From: John Lentini <pencilbase@aol.com>
Sent: Friday, January 26, 2018 1:08 AM
To: Chris Kehoe; tracytom888@gmail.com
Subject: Vape Rest, 2081 E. Main Str PB 2017-22
Attachments: VAPEREST01242018.pdf; VAPEREST01252018.pdf

MEMORANDUM

SUBJECT: PB 2017-22 Application of Tracy Cong for Amended Site Plan approval for the conversion of a portion of an existing retail store (DT Vape Shop) to a take-out restaurant for property located at 2081 E. Main St. (Cortlandt Boulevard).

PLOT PLAN
 scale 1" = 20'-0"

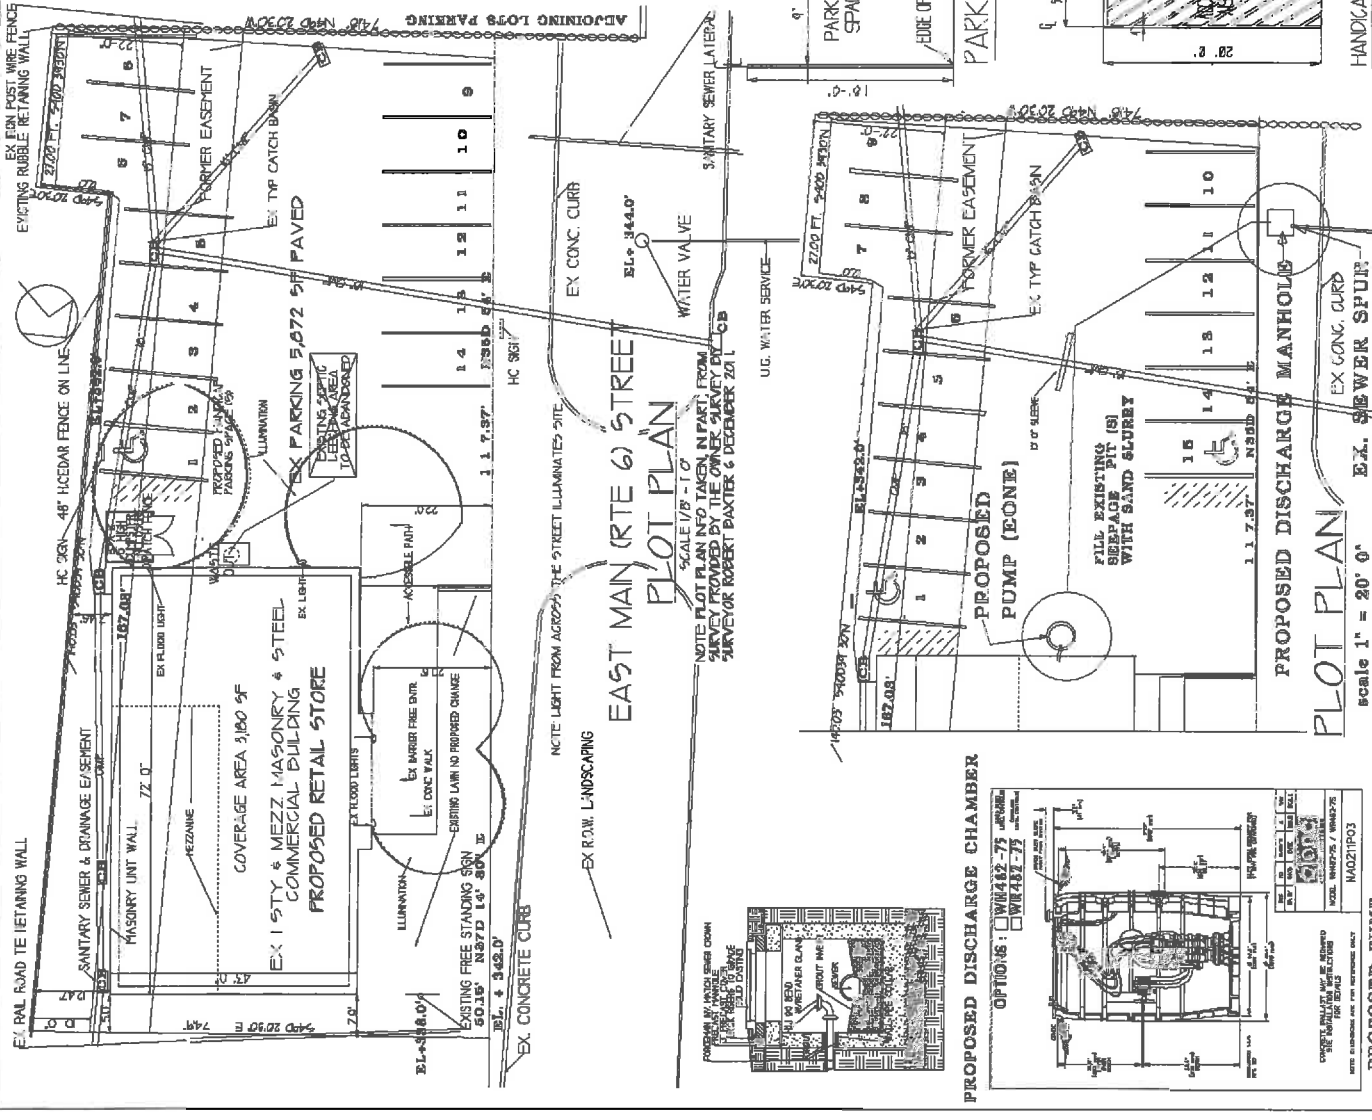
- b. A zoning data chart shall be added to the subject drawing.
 - c. The subject drawing should show the proposed location, direction, power and time of any existing and proposed outdoor lighting.

- f. The subject drawing should show a complete landscape plan with the types, sizes and locations of all existing and proposed plantings. Quantify on the subject site plan all proposed areas of landscape coverage.

- g. Show all required building setback lines on the subject drawing.
 - h. The subject drawing shall show the existing sewage disposal system. The applicant's engineer has indicated that the subject property is currently using a septic system but a connection to public sewer is possible. The subject drawing shall be revised to show the proposed connection with pipe sizes, grades, manholes and other facilities as required.

- i. The subject drawing shows 15 parking spaces and one handicapped space. Parking for the existing Vape Shop should be based on 1 space/ 300 sq. ft. of habitable ground floor space and 1 space/500 sq. ft. of habitable floor space on the upper floor. Parking for the restaurant should be based on 1 space/50 sq. ft. of dining area and such employee parking as determined by the Planning Board. A parking chart with these calculations should be added to the drawing for the Board to determine if sufficient parking exists on site.

- j. The subject drawing shall be revised to show a screened garbage enclosure. Currently dumpsters are located adjacent the building, unscreened, in the area shown on the plan as parking space #1.

- k. The subject drawing should be revised to show the approximate locations of adjacent homes and dwellings. The drawing shall also show the existing fence located behind the building and parking area that screens the adjacent residences on Crescent Dr.

- l. Show the approximate location of the existing water line servicing the subject building.
 - m. Provide two copies of a recent boundary survey for the subject property and add the metes and bounds and survey reference to the subject site plan.

4. Add the dimensions of the parking spaces to the subject drawing. Revise the handicapped space as per New York State Code. The handicapped space is proposed in an existing grass area parallel to Route 6 near the access to the site. The proposed space should be re-located to the satisfaction of the Director of Technical Services as the proposed location has the potential to cause traffic conflicts.

Please note, we have decided not to alter the physical site , by adding a parking space, and have, instead proposed to eliminate former parking space number 1 in order to accommodate the trash enclosure. I have calculated the need for 12 customer spaces and have added 2 employee spaces., The loft/mezzanine does not meet the standards of habitable or occupied and has a low ceiling. There is only a need for one employee parking space for each business. Please note there is public transportation nearby and sidewalks that serve the site. The employees are driven there or car pool.

The owner is not adverse to providing new landscaping if it is a requirement of our application, however, if we do not disturb the site the landscaping may not be mandatory. I believe that your comments , relative to landscaping , resulted from our previous proposal to remove part of the lawn in order to provide a parking space and the potential for non conformity of required landscape area.

Please also note, I simply pasted the contents of a past approval, for the sewerage pumping system, and did not alter the site as proposed before. On retrospect I can see where this might cause confusion because the indicated parking spaces shown are erroneous now.. I can remove the parking spaces from the digital and submit additional plans if you feel that it is necessary. In any event the full site plan at the top of the page is our proposal. The partial site plan indicating the sewer details is only provided for the proposed means to connect to the available sewer.

FRONT ELEVATION

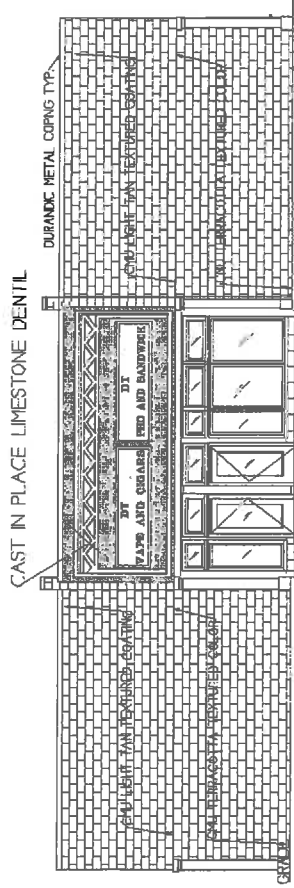
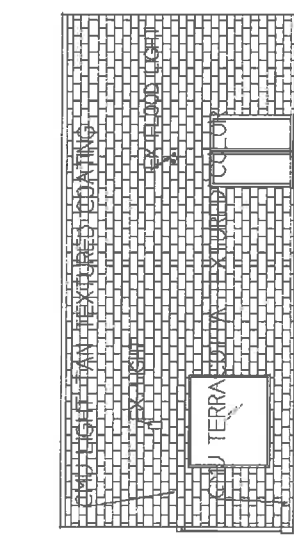
- d. The floor plans and elevation drawings shall be placed on separate drawing sheets. In addition, the applicant shall submit elevation drawings for all four (4) building elevations.

- e. The front elevation drawing shall be revised to show how the signage for the two (2) different businesses.
